As Built Changes in Red 8-8-86

SR 90
3RD LAKE WASHINGTON FLOATING BRIDGE - PONTOONS - PHASE 1
KING COUNTY

TOP SLAB PLAN PONTOONS F-I & K-O

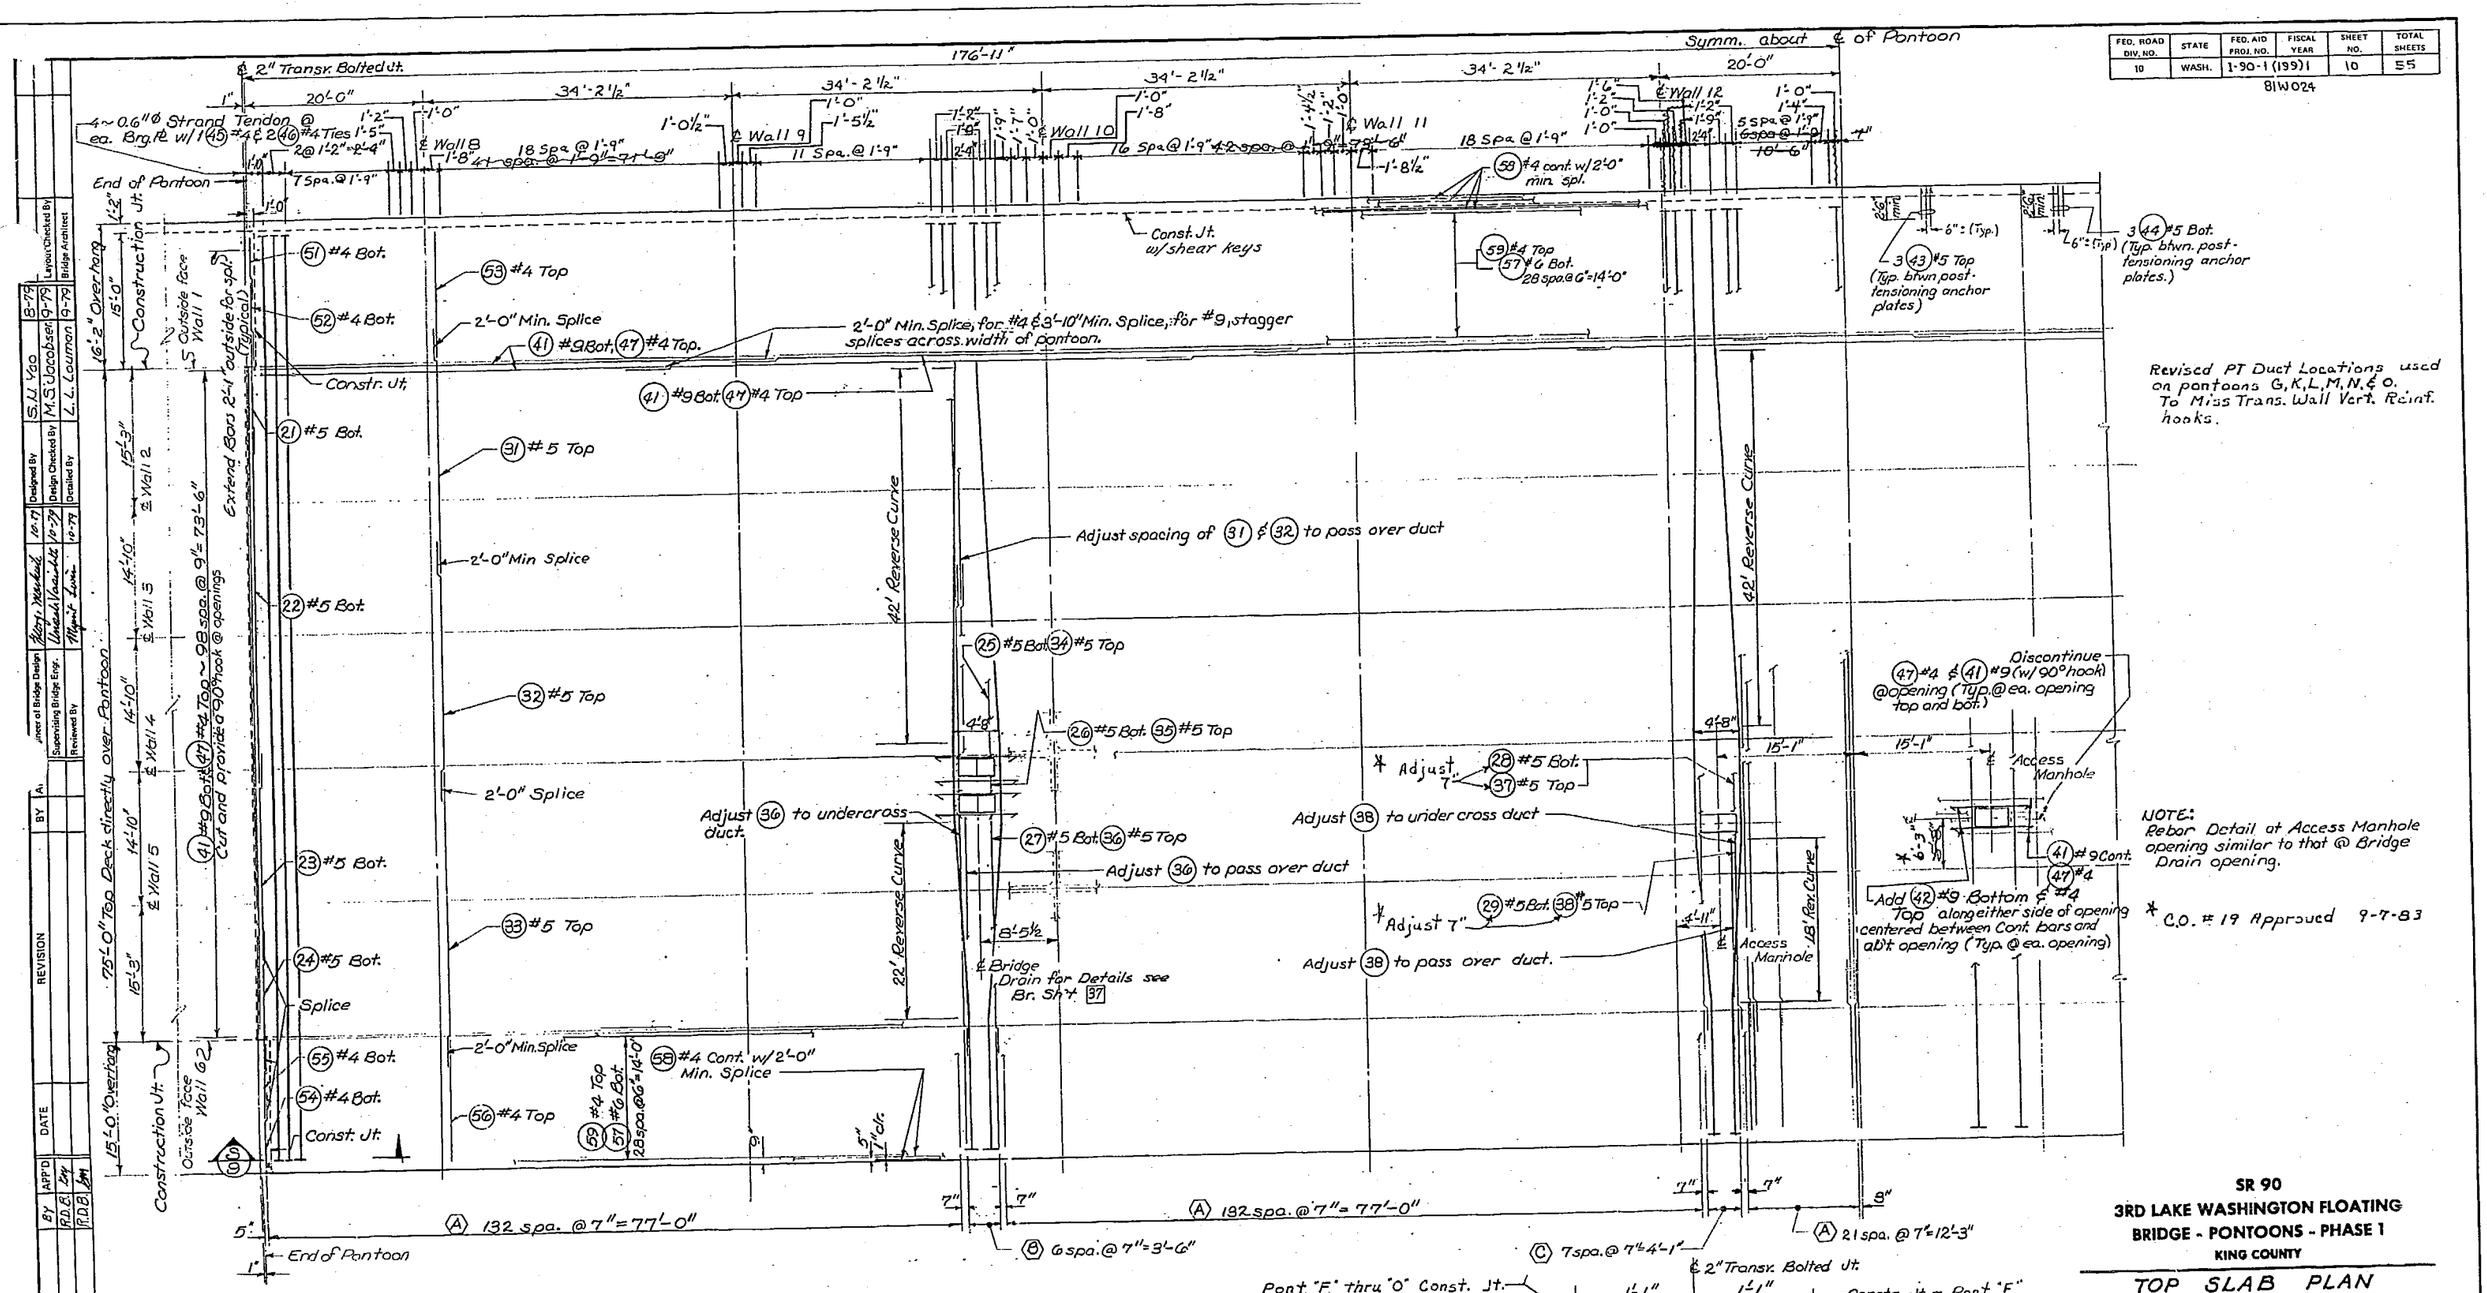
Revised PT Duct Locations used on pontoons G, K, L, M, N & O. To Miss Trans. Wall Vert. Reinf. hooks.

* C.O. # 19 Approved 9-7-83

Revised C.O. 42 Appd 5-31-84

TOP SLAB SECTIONS
PONTOONS F-O

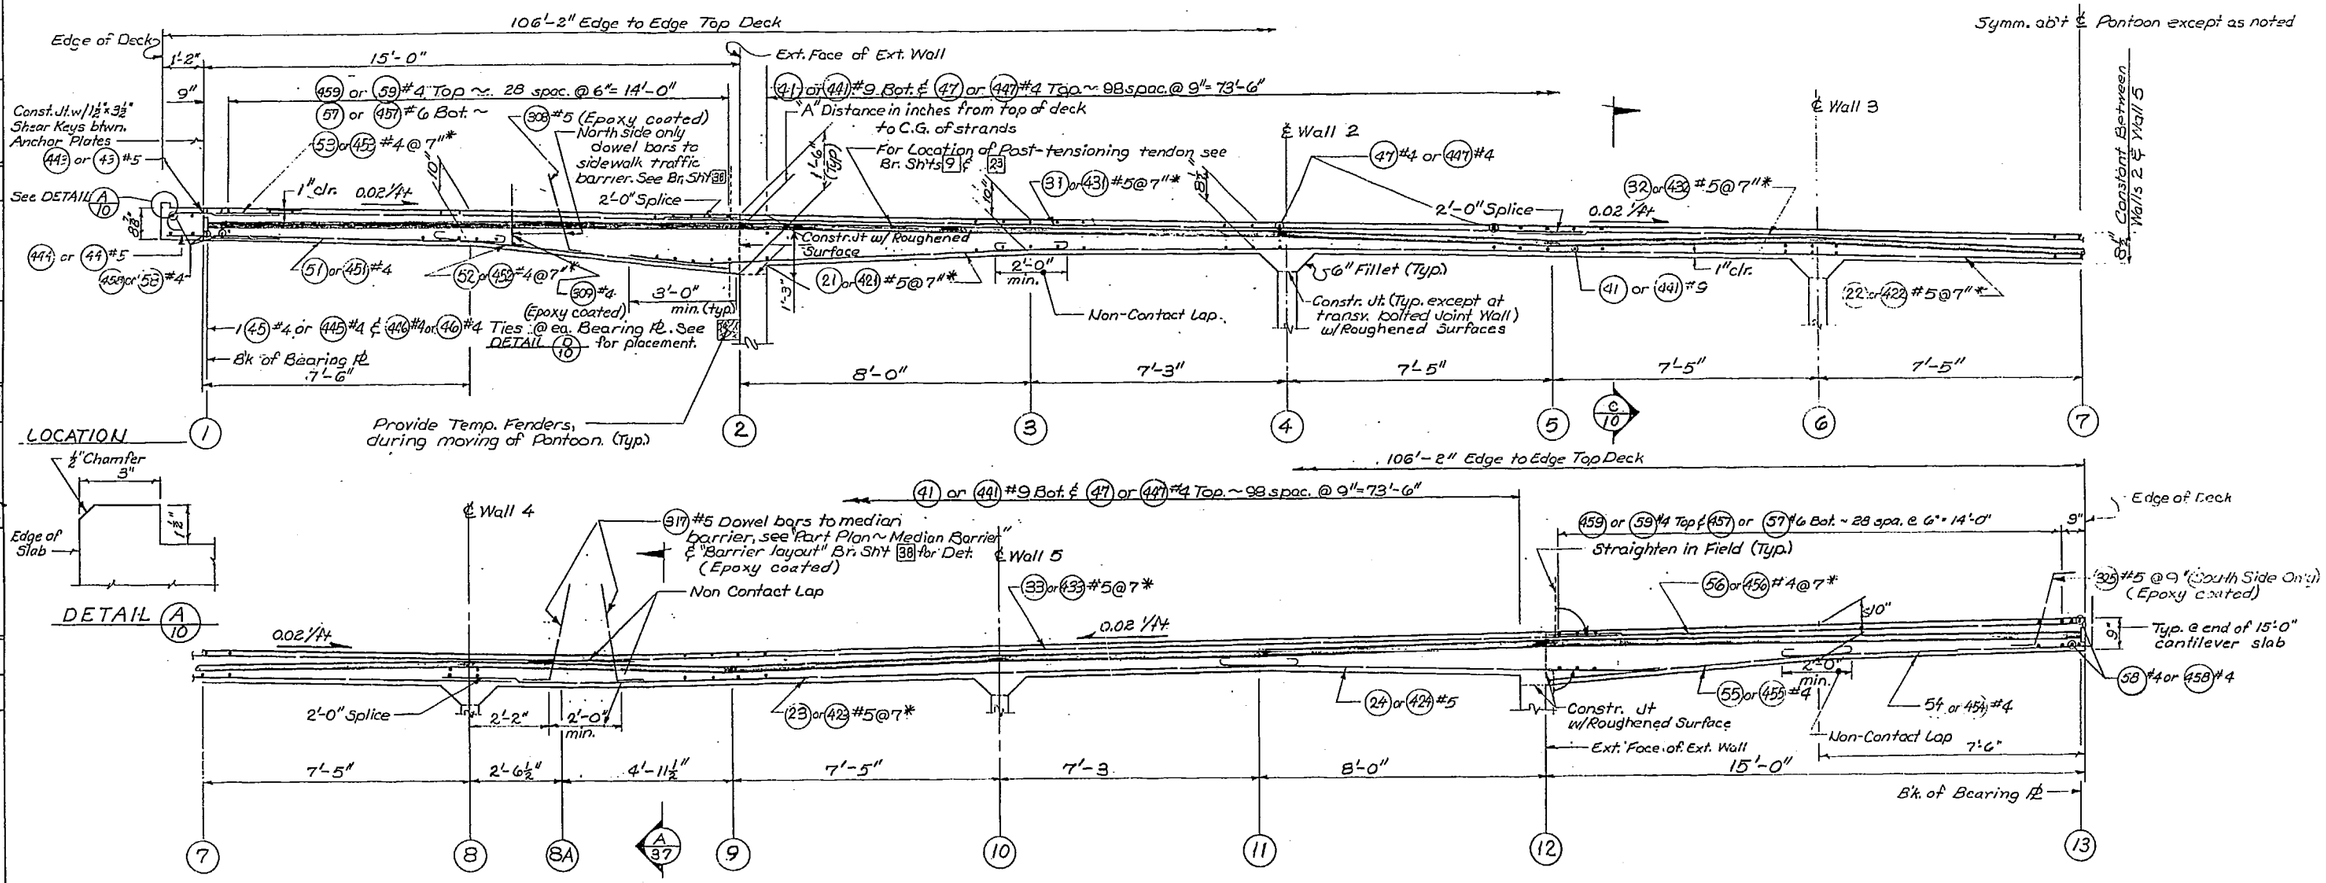
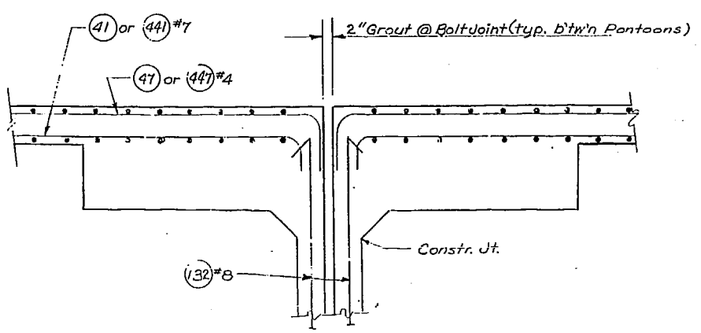
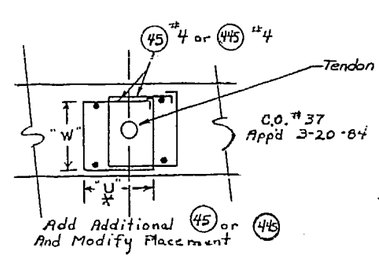
* Note: Mark 45 in Pontoons K, L, M, N, & O Will have an increased "U" Dimension from 8.5" to 9.5".
